# ***ARBORICULTURAL IMPACT ASSESSMENT***

## **PROPOSED COMMERCIAL DEVELOPMENT – TOR HILL WORKS, CONSTITUTION HILL, WELLS, SOMERSET, BA5 3NT**

August 2023

This report is intended to respond to comments received as part of the planning application, 2021/1703/FUL, relating to the proposed commercial development on land at Tor Hill Works, Constitution Hill, Wells, Somerset, BA5 3NT. This document has been produced to demonstrate that the implications of the proposed development in relation to the arboricultural, landscape and cultural (conservation) value of the trees and hedgerows on the site have been fully considered during the detailed design process and should be read alongside the proposed masterplan.

## Appendix 3 – Tree Protection Plan

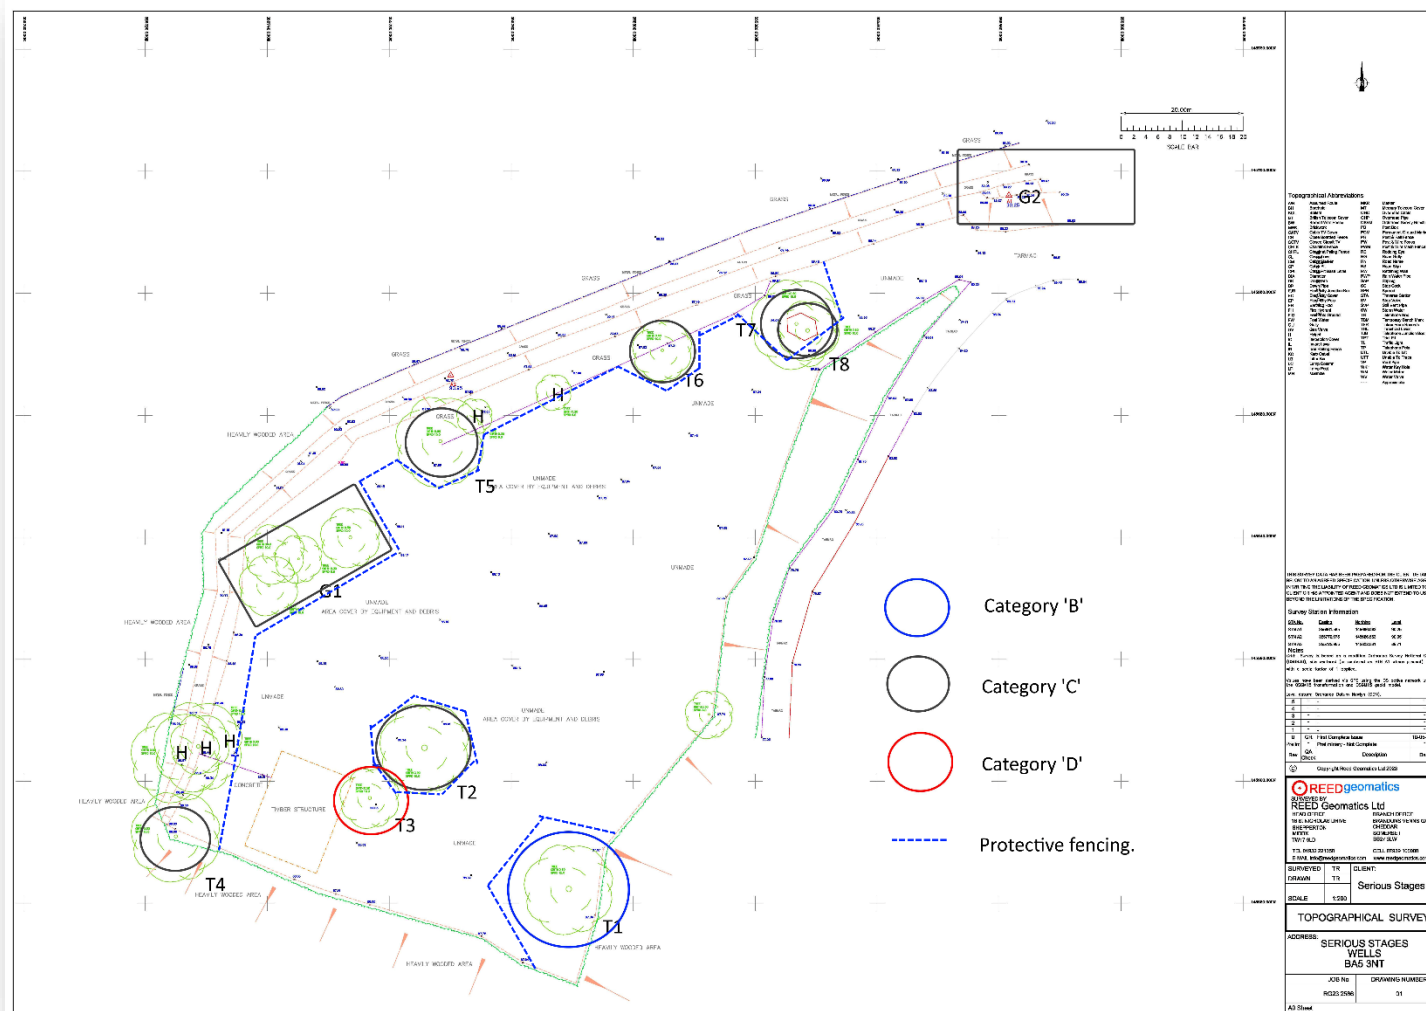
The submitted tree survey does not comply with the British Standard and does not include a Tree Survey / Constraints Plan or Tree Protection Plan for any retained trees.

Absence of a Tree Survey / Arboricultural Impact Assessment / Tree Constraints Plan / Draft Tree Protection Plan – that complies with BS5837:2012.

It is proposed to retain all the trees on the site other than T3 which is recommended to be felled. To avoid future conflicts between the storage of materials and RPAs it is proposed to maintain a 5m landscape buffer along the eastern side of the north-western bank. Trees within the main storage areas should have their RPAs protected through permanent post and sheep netting fencing to avoid any future damage to their branches or RPAs.

The Tree Protection Plan, see Appendix 3, shows the location of the proposed tree protection barriers.
